Remarks

Applicant notes that the Patent Office has allowed pending claims 1 to 22. Claims 1 and 12 are amended.

Objections to the Drawings

FIG. 1

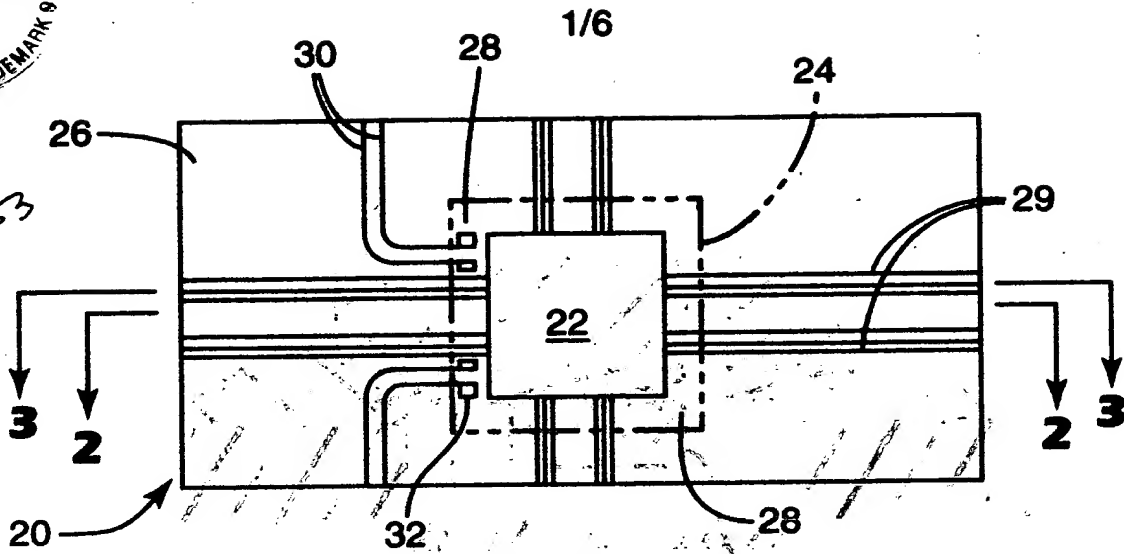
Fig. 1 has been amended as follows:

The line format of the die (24) has been changed to “phantom.” Support for this amendment is found on page 6, lines 23-24.

FIG. 2

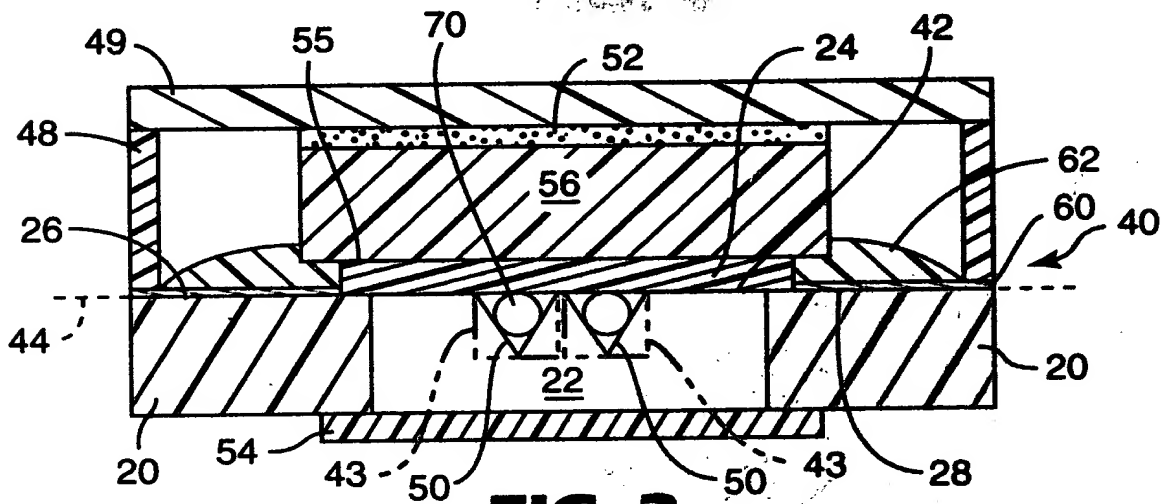
Fig. 2 has been amended as follows:

The cross-hatching of the package frame (20) has been changed to indicate an insulative part. Support for this amendment is found at page 7, lines 7-24.

The cross-hatching has been removed from the aperture (22). Support for this amendment is found at page 9, lines 28-31.

The line format for optical micro-mechanical devices (43) has been changed to “phantom.” Support for this amendment is found at page 7, line 31-page 8, line 1.

The cross-hatching for the flex circuit (60) has been changed to indicate a conductive material. Support for this amendment is found at page 8, lines 24-26.

The cross-hatching has been removed from the lenses (70) shown in end-view. Support for this amendment is found at page 2, lines 27-31.

FIG. 3

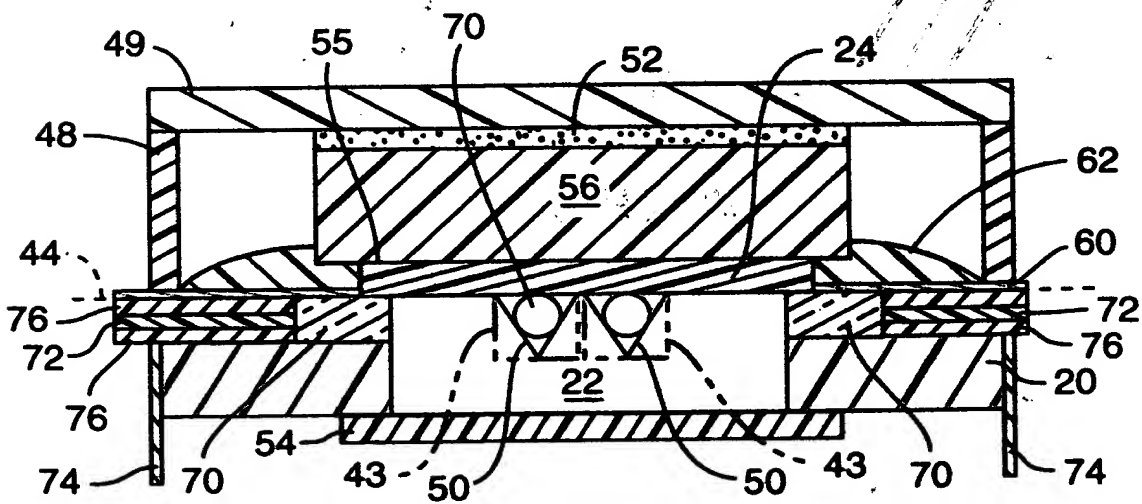
Fig. 3 has been amended as follows:

The cross-hatching of the package frame (20) has been changed to indicate an insulative part. Support for this amendment is found at page 7, lines 7-24.

The cross-hatching has been removed from the aperture (22). Support for this amendment is found at page 9, lines 28-31.

The line format for optical micro-mechanical devices (43) has been changed to “phantom.” Support for this amendment is found at page 7, line 31-page 8, line 1.

The cross-hatching for the flex circuit (60) has been changed to indicate a conductive material. Support for this amendment is found at page 8, lines 24-26.

The cross-hatching has been removed from the lenses (70) shown in end-view. Support for this amendment is found at page 2, lines 27-31.

FIG. 4

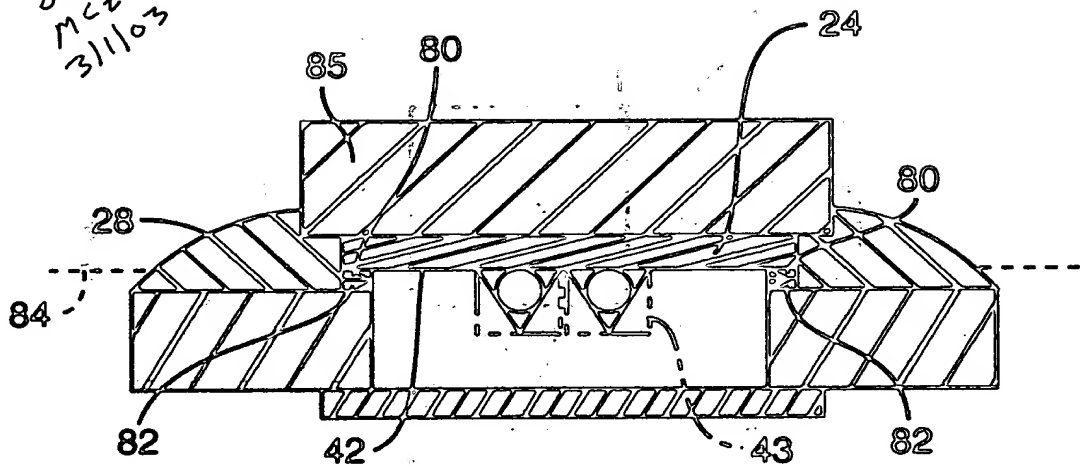
Fig. 4 has been amended as follows:

The cross-hatching of the package frame has been changed to indicate an insulative part. Support for this amendment is found at page 7, lines 7-24.

The cross-hatching has been removed from the aperture. Support for this amendment is found at page 9, lines 28-31.

The line format for optical micro-mechanical devices (43) has been changed to “phantom.” Support for this amendment is found at page 7, line 31-page 8, line 1.

The cross-hatching has been removed from the lenses shown in end-view. Support for this amendment is found at page 2, lines 27-31.

FIG. 5

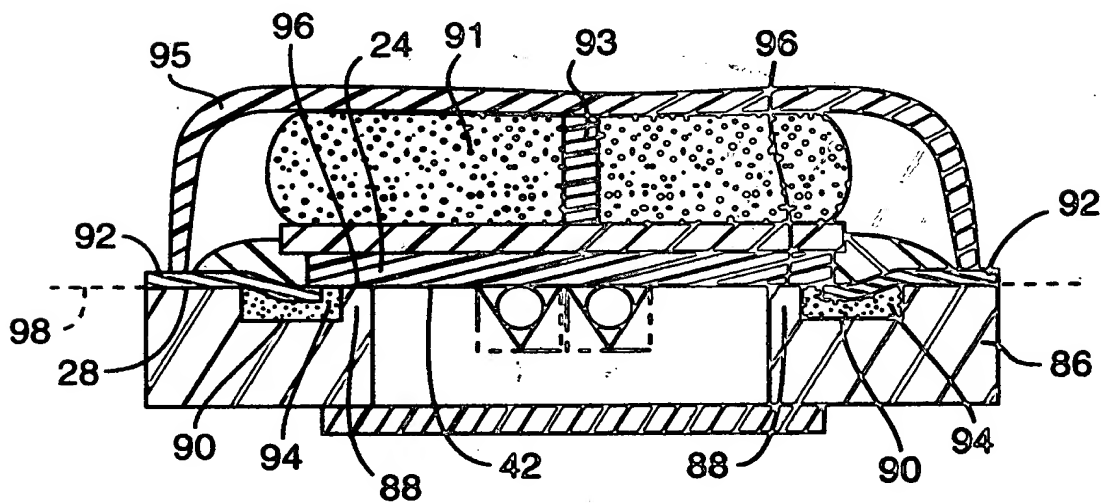
Fig. 5 has been amended as follows:

The cross-hatching of the package frame (86) has been changed to indicate an insulative part. Support for this amendment is found at page 7, lines 7-24.

The cross-hatching has been removed from the aperture. Support for this amendment is found at page 9, lines 28-31.

The line format for optical micro-mechanical devices has been changed to “phantom.” Support for this amendment is found at page 7, line 31-page 8, line 1.

The cross-hatching for the flex circuit (92) has been changed to indicate a conductive material. Support for this amendment is found at page 11, lines 4-6.

The cross-hatching has been removed from the lenses shown in end-view. Support for this amendment is found at page 2, lines 27-31.

FIG. 6

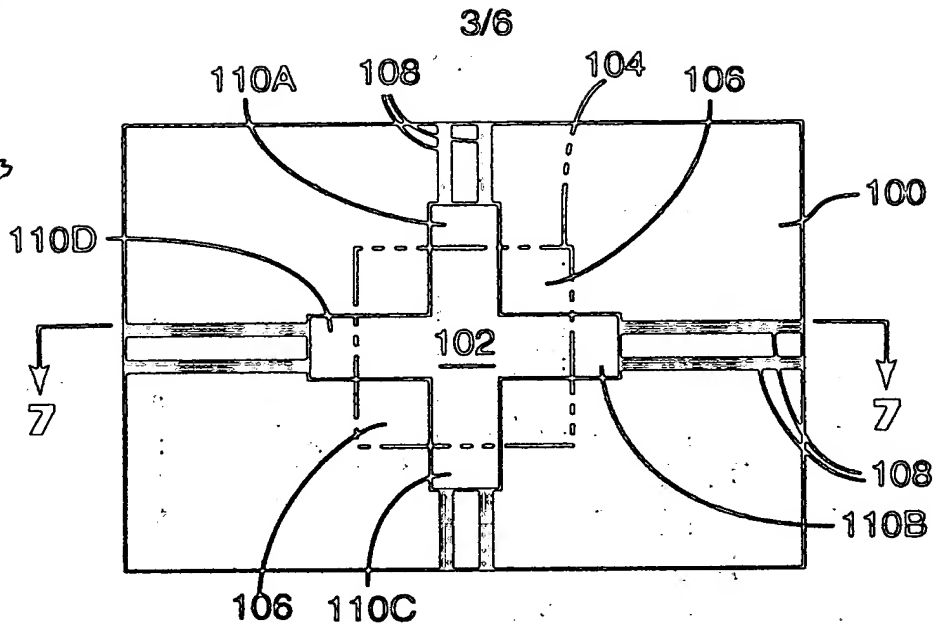
Fig. 6 has been amended as follows:

The line format for the die (104) has been changed to “phantom.” Support for this amendment is found at page 11, lines 30-31.

FIG. 7

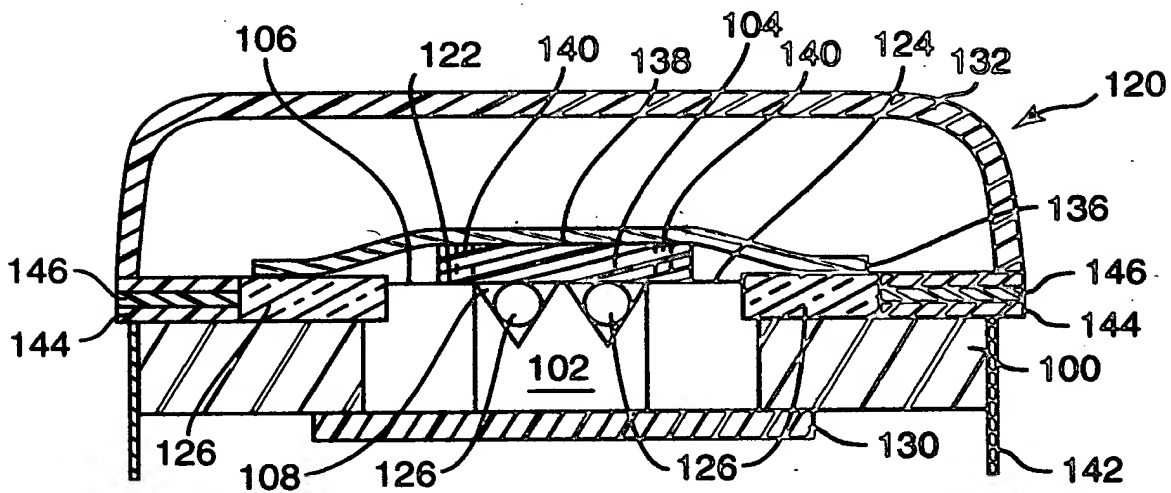
Fig. 7 has been amended as follows:

The cross-hatching of the package frame (100) has been changed to indicate an insulative part. Support for this amendment is found at page 7, lines 7-24.

The cross-hatching has been removed from the aperture (102). Support for this amendment is found at page 9, lines 28-31.

The cross-hatching for the flex circuit (136) has been changed to indicate a conductive material. Support for this amendment is found at page 12, lines 23-27.

The cross-hatching has been removed from the lenses (126) shown in end-view. Support for this amendment is found at page 2, lines 27-31.

FIG. 8

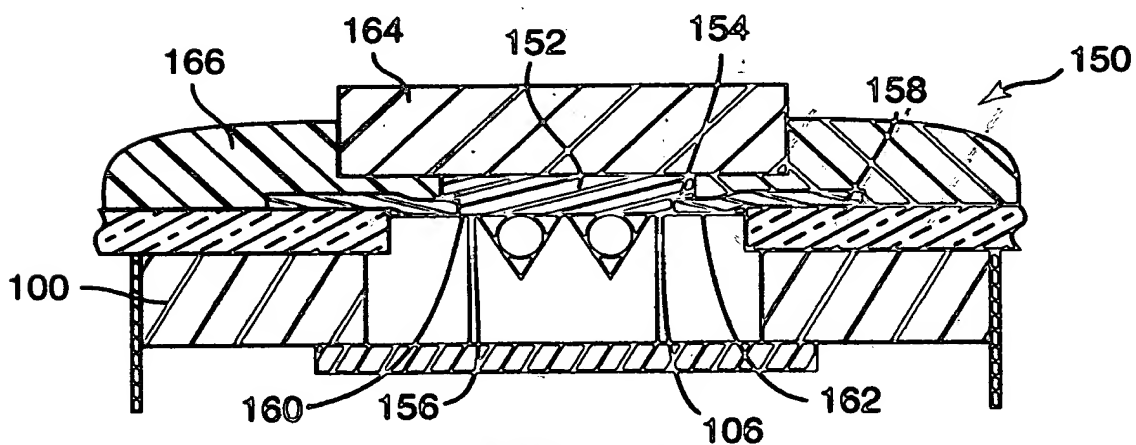
Fig. 8 has been amended as follows:

The cross-hatching of the package frame (**100**) has been changed to indicate an insulative part. Support for this amendment is found at page 7, lines 7-24.

The cross-hatching has been removed from the aperture. Support for this amendment is found at page 9, lines 28-31.

The cross-hatching for the flex circuit (**158**) has been changed to indicate a conductive material. Support for this amendment is found at page 13, lines 2-3.

The cross-hatching has been removed from the lenses shown in end-view. Support for this amendment is found at page 2, lines 27-31.

FIG. 10

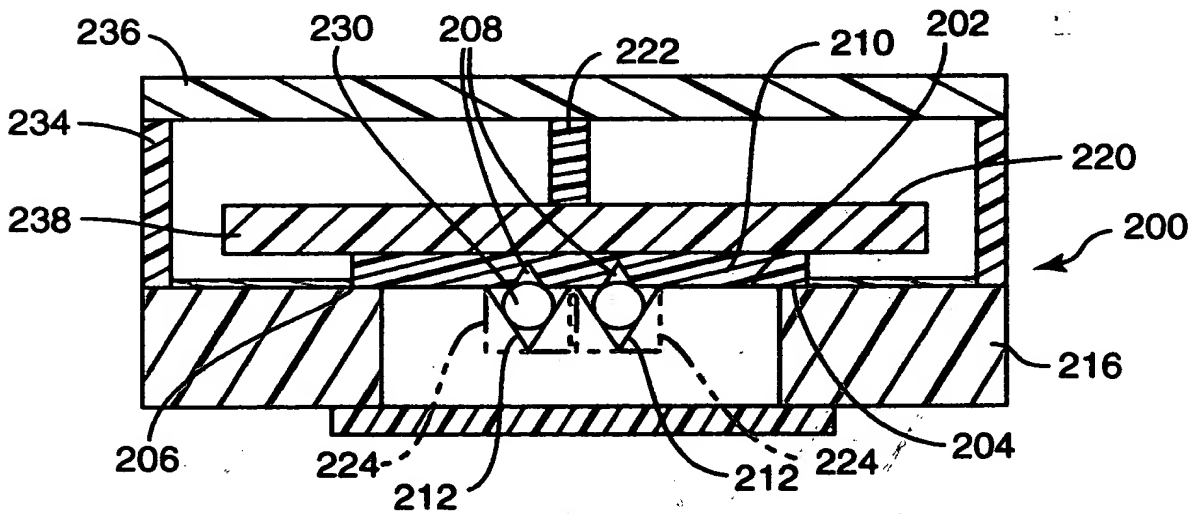
Fig. 10 has been amended as follows:

The cross-hatching of the package frame (**216**) has been changed to indicate an insulative part. Support for this amendment is found at page 7, lines 7-24.

The cross-hatching has been removed from the aperture. Support for this amendment is found at page 9, lines 28-31.

The cross-hatching for the flex circuit has been changed to indicate a conductive material. Support for this amendment is found at, e.g., page 13, lines 2-3.

The line format for optical micro-mechanical devices (**224**) has been changed to “phantom.” Support for this amendment is found at page 7, line 31 – page 8, line 1.

The cross-hatching has been removed from the lenses (**230**) shown in end-view. Support for this amendment is found at page 2, lines 27-31.

FIG. 12

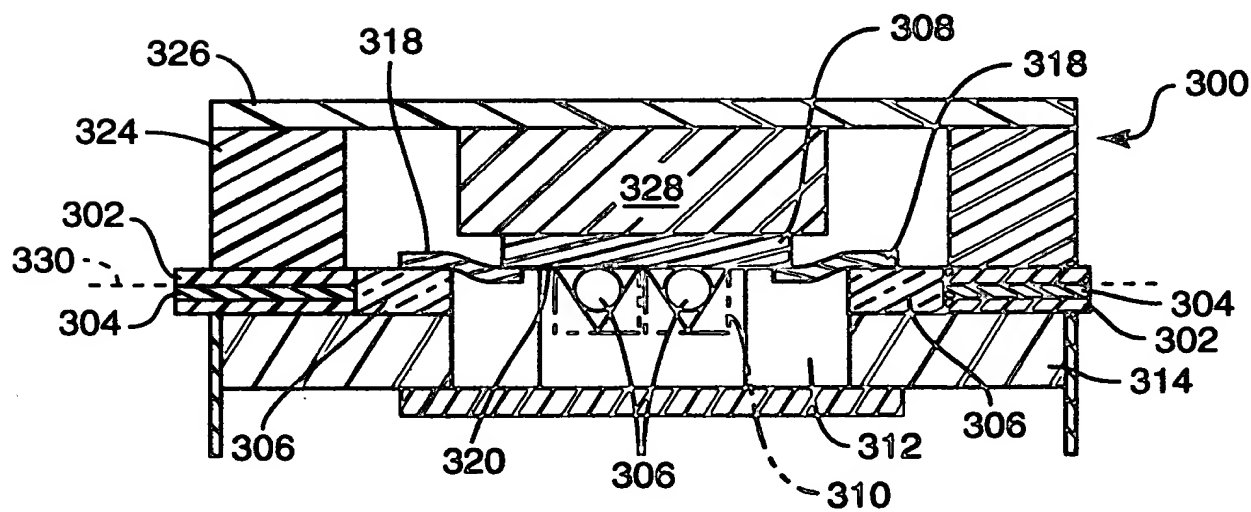
Fig. 12 has been amended as follows:

The cross-hatching of the package frame (**314**) has been changed to indicate an insulative part. Support for this amendment is found at page 7, lines 7-24.

The cross-hatching has been removed from the aperture (**312**). Support for this amendment is found at page 9, lines 28-31.

The line format for optical micro-mechanical devices (**310**) has been changed to “phantom.” Support for this amendment is found at page 7, line 31-page 8, line 1.

The cross-hatching for the flex circuit (318) has been changed to indicate a conductive material. Support for this amendment is found at page 14, lines 12-15.

The cross-hatching has been removed from the lenses (306) shown in end-view. Support for this amendment is found at page 2, lines 27-31.
